AMENDMENTS TO THE DRAWINGS

Application No. 10/618,133
Amdt. mailed December 5, 2005
Attorney Docket No. ARA-US-P1

FIG.3

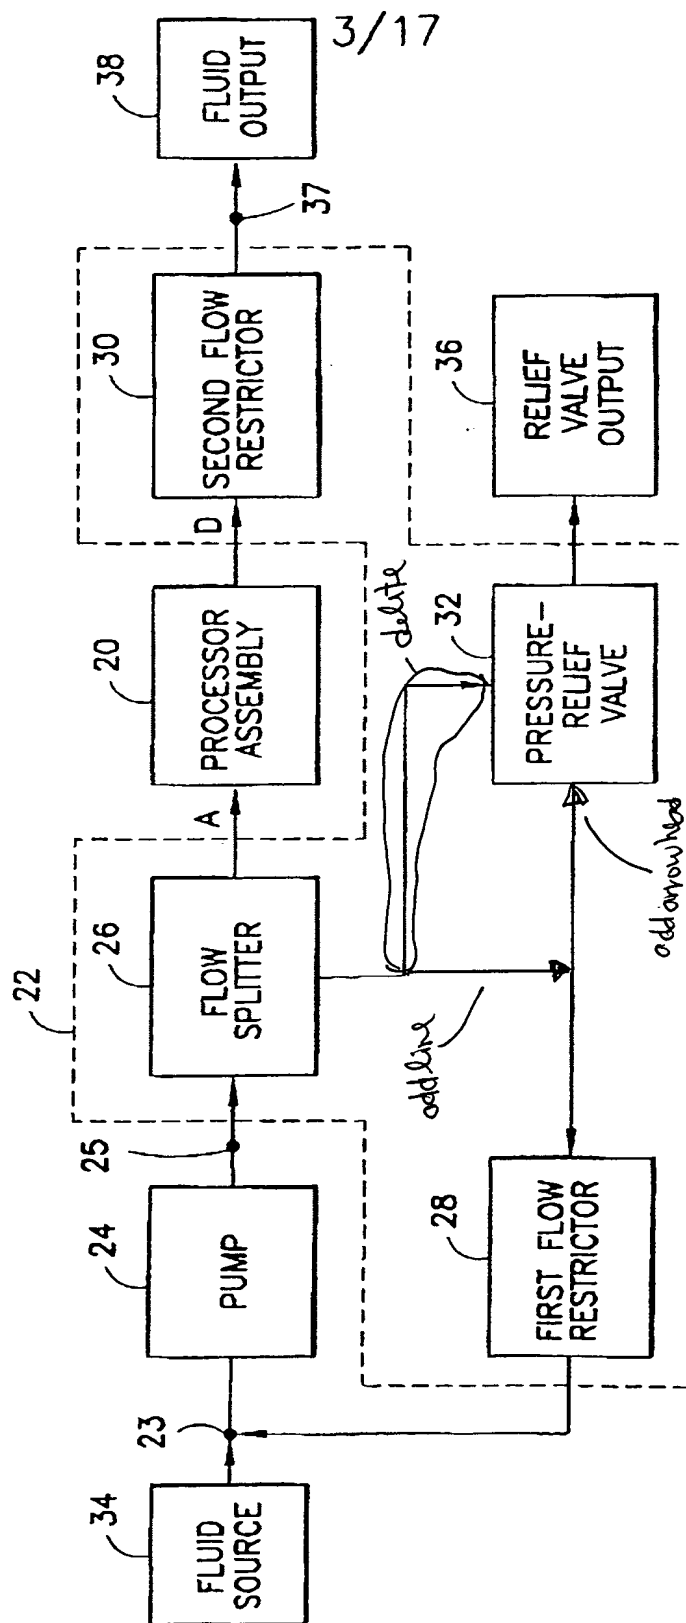
FIG. 3 has been amended to change the positioning of the line leading from the flow splitter 26 to the pressure relief valve 32 and conform FIG. 3 to FIGS. 11A and 13.

FIG. 10A

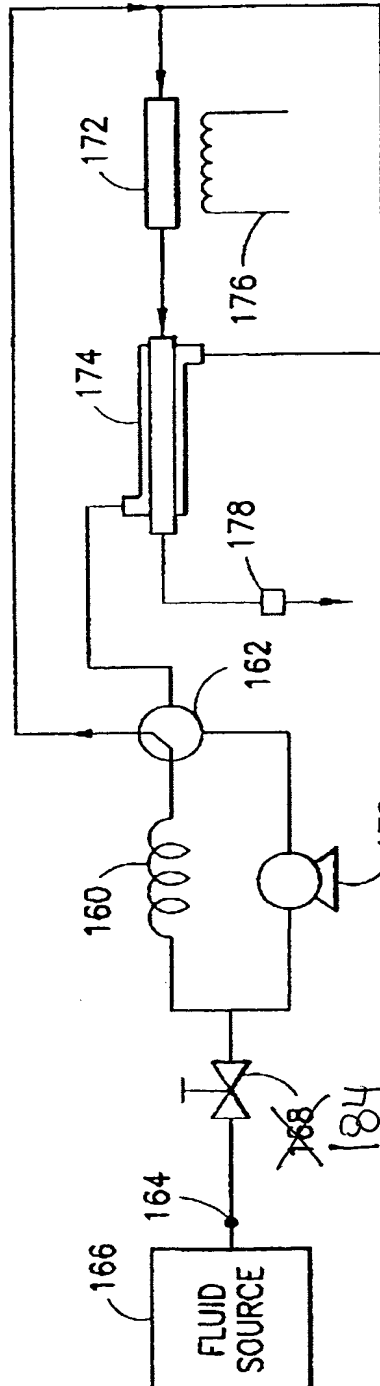
FIGS. 10A and 10B have been amended by changing element number "168" to element number "184" as directed by the Examiner.

Re-number
168 to 184

FIG. 10B

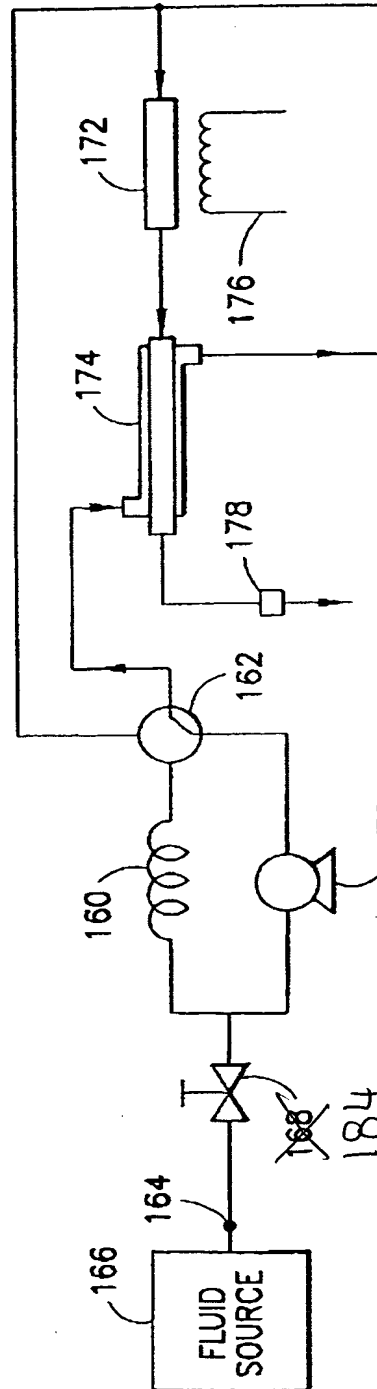
Re-number
168 to 184

FIG.11A

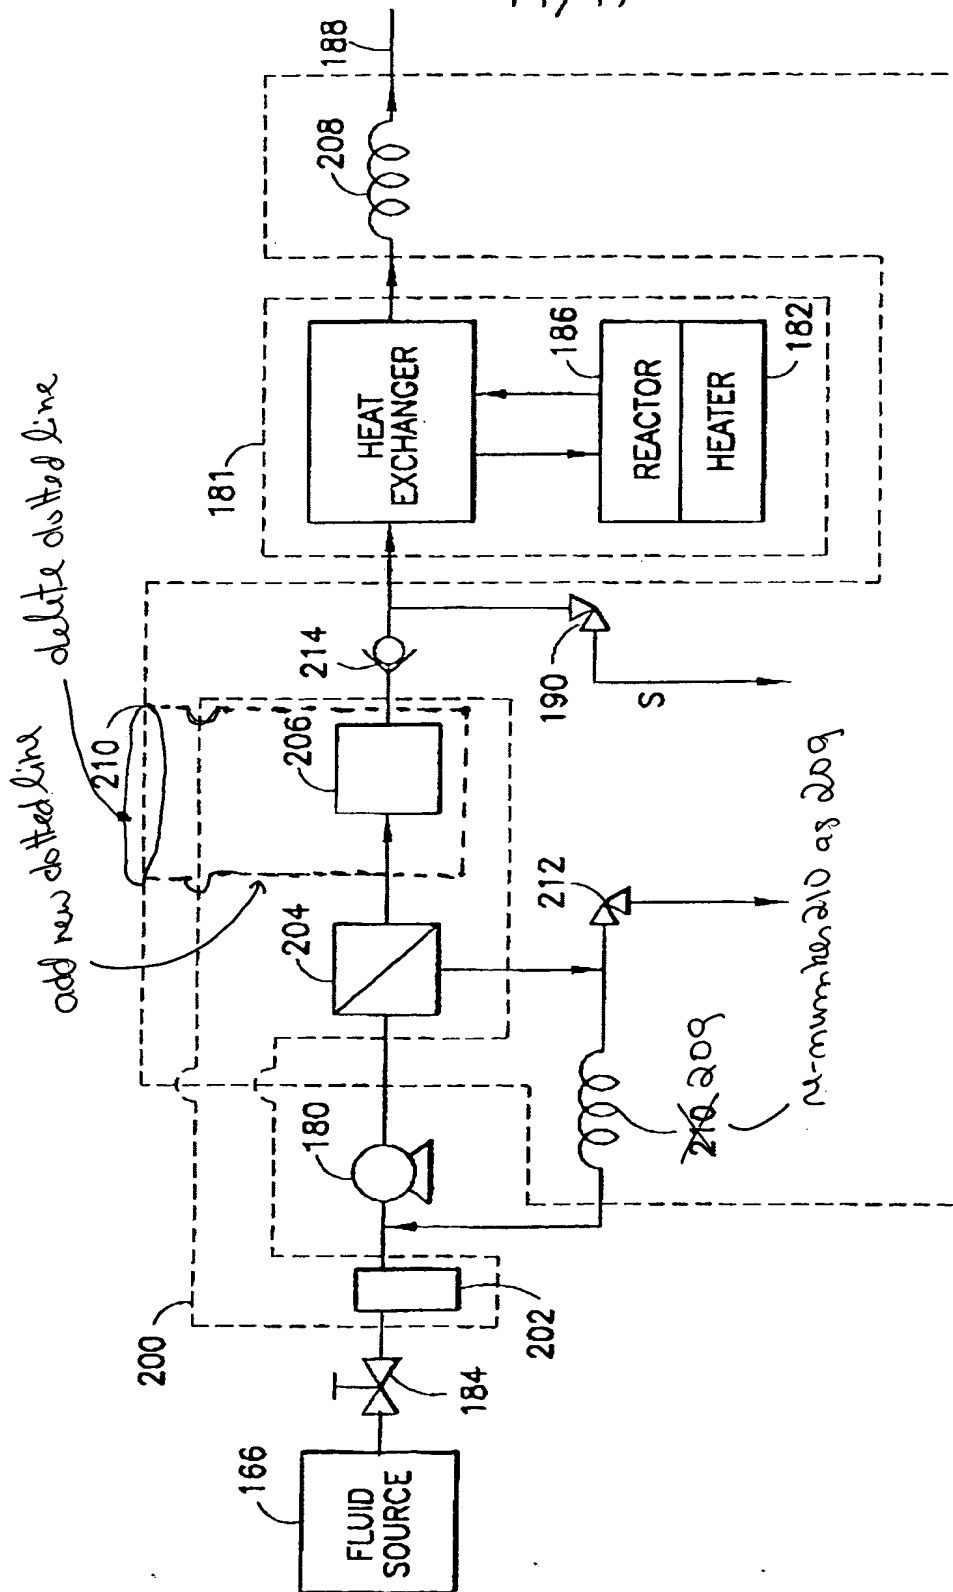
FIG. 11A has been amended to correct drafting errors by deleting the element number 210 having a lead line going to a flow restrictor and renumbering it as element number 209. Also, the dotted line identifying the elements included in element 210 (processor assembly) has been amended to exclude ion exchange device 206. Support for these amendments can be found in the Specification at page 30, line 13 to 24.
